ELECTRONICS CORRIGENDA

September 1996/Issue 105

Sound-to-Light Unit Page 50

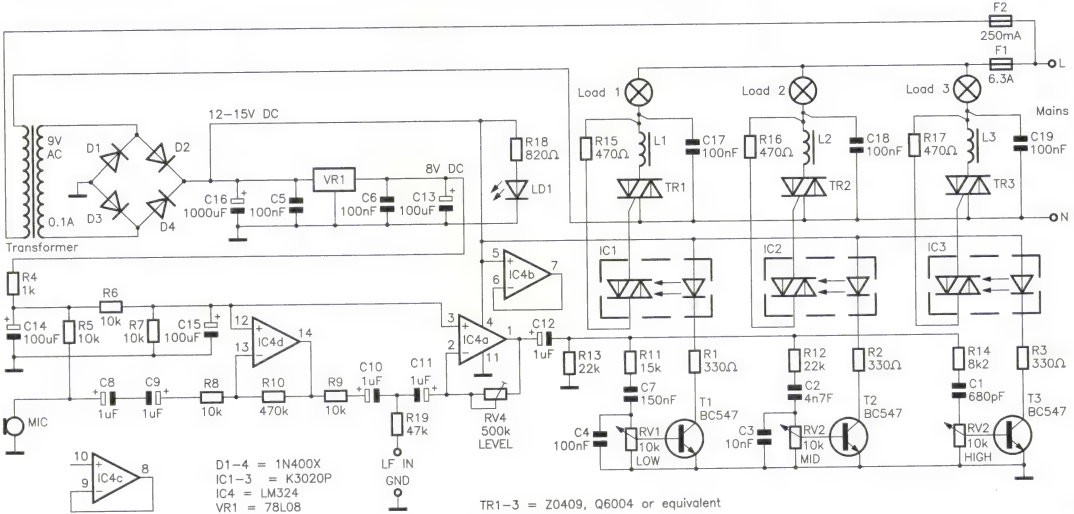
The circuit diagram shows TR1 to TR3 connected to the 12-15V DC rail, they should cross at these points and not be joined, see amended drawing (right). The layout on the PCB is correct.
